Technical Bulletin

Number: 080
Date Issued: 02/04/11
Expiration Date: n/a

Subject/Key Words:	Fire System CO2 Actuator Inadvertent Discharge			
Classification:	<input type="checkbox"/> Informational	<input checked="" type="checkbox"/> Mandatory	<input checked="" type="checkbox"/> Safety Alert	<input type="checkbox"/> PM Impact
	<input type="checkbox"/> Warranty Impact	<input type="checkbox"/> Purchase Parts	<input type="checkbox"/> No Charge For Parts expires ___/___/___. Reference this TB# when ordering NC parts.	
Applicable Akrion Procedures:	None			
Parts/Reference Documents:	Actuator: 216589-001, 00013216-00, 4090861A-00			
Attachments:	ANSUL Bulletin No. 5706

Bulletin No. 5706

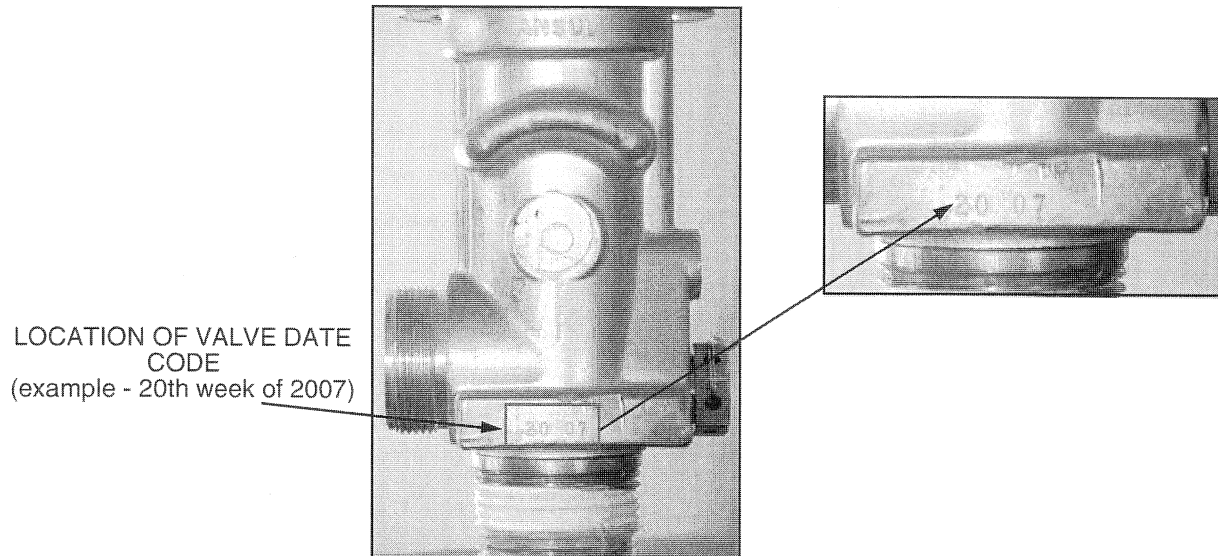
Tyco Fire Suppression & Building Products ("TFS&BP") has received isolated reports of ANSUL High Pressure CO₂ Systems inadvertently discharging. We have discovered that an internal pressure vent on the cylinder valve may not be adequately venting pressure and, under certain conditions, this may cause a cylinder in the system to actuate without the sounding of an alarm, which would then cause all cylinders on this specific system to actuate.

TFS&BP has determined through internal testing that valves with the following date codes (week-year) may be affected:

High Pressure CO₂ valves with a date code range of 10-07 to 06-08.

These valves were sold by TFS&BP from March 2007 through July 2009.

The date code is located on the flat opposite of the valve outlet. The date code represents the **week and year** the valve was manufactured.

Please follow the Pneumatic Actuation Port Plug Replacement Procedure on Page 3 for any ANSUL High Pressure CO₂ valves with a date code range of 10-07 to 06-08 that you identify.

- Immediate steps should be taken to identify the valve date code and complete the Pneumatic Actuation Port Plug Replacement Procedure. A total number of affected valves and their locations should be provided to TFS&BP.
- At the next service/ maintenance cycle, the CV-98 valve should be replaced. TFS&BP will work with you to develop a replacement schedule and will provide you the necessary replacement product to be installed in place of the affected valves.
